## APPENDIX A – ENVIRONMENTAL HEALTH COMMENTS

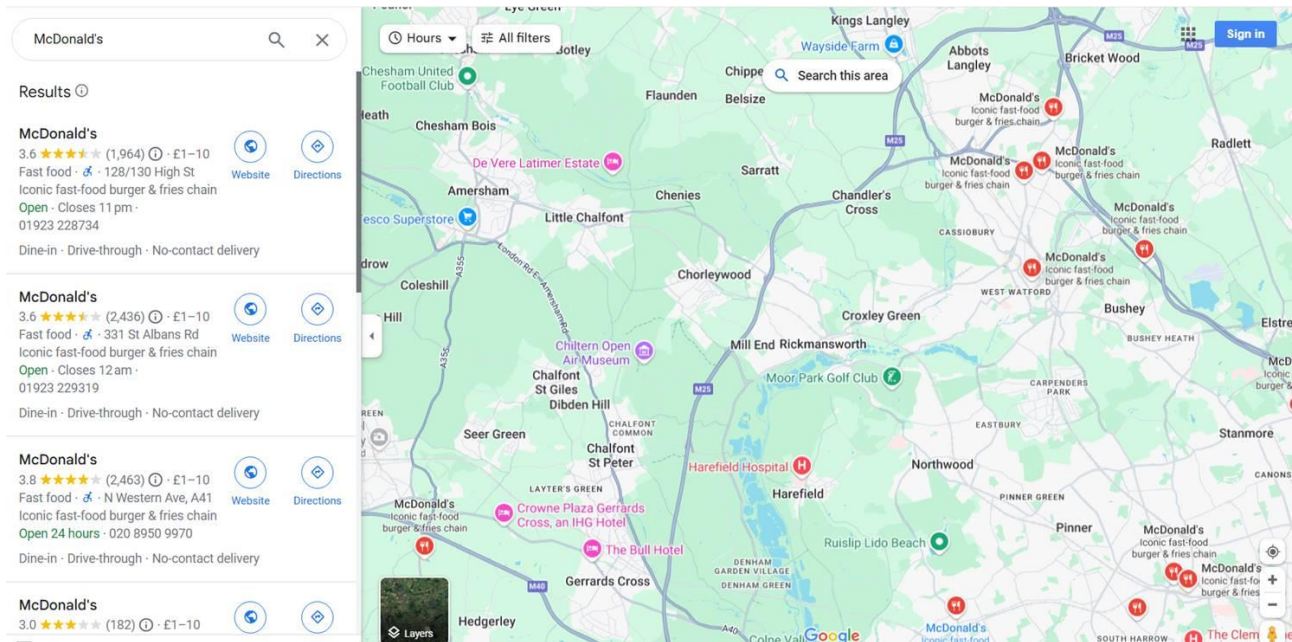
Although the site is located within the town centre, to the rear are a block of flats as shown in the following picture from Google Streetview. This indicates a high number of potential receptors.

Whilst the revised report includes additional information on these types of deliveries, I do not consider the potential impacts have been fully evaluated and therefore question how they can be adequately controlled to prevent a loss of amenity to local residents.
